Re: Case Re: 323761 – Cooloo Wind Farm

Applicant : Neoen Renewables Ireland Limited

Site Location: Located within the townlands of Cloondahamper, Cloonascragh, Elmhill, Cooloo, Lecarrow, Dangan Eighter, Lissavally and Slievegorm, Co.Galway

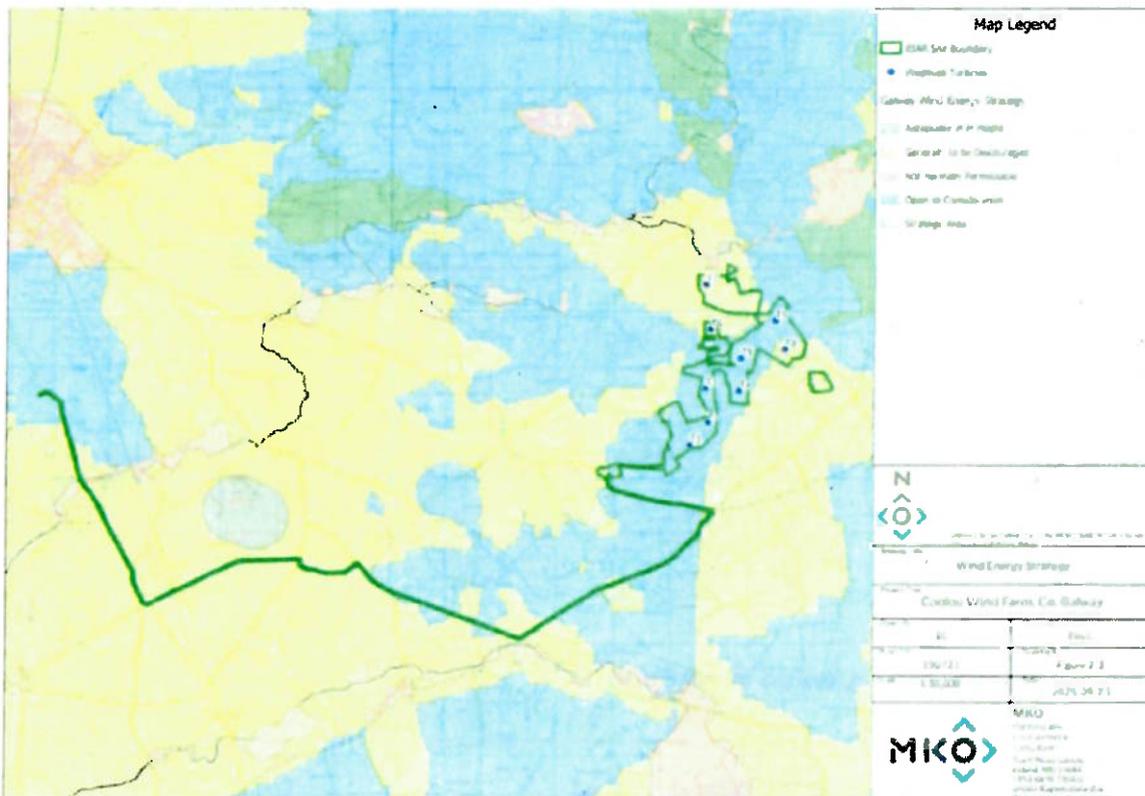
Three of the proposed turbines – numbers 6, 7 and 8 are in locations that are considered "generally to be discouraged" by the Galway County Council Wind Potential report, for such developments.

I'd like to draw to your attention the location of these particular proposed turbines laid out on a map below, from the planning application drawings, which demonstrates that they are in the area which is stated "generally to be discouraged" for such developments.

This project is classed as a Strategic Infrastructure Development, because it meets the 50MW threshold. Without the three turbines which are in the generally discouraged area, the electricity-generating capacity of the windfarm would be reduced to between 36MW to 42MW which would mean the development couldn't be considered an SID.
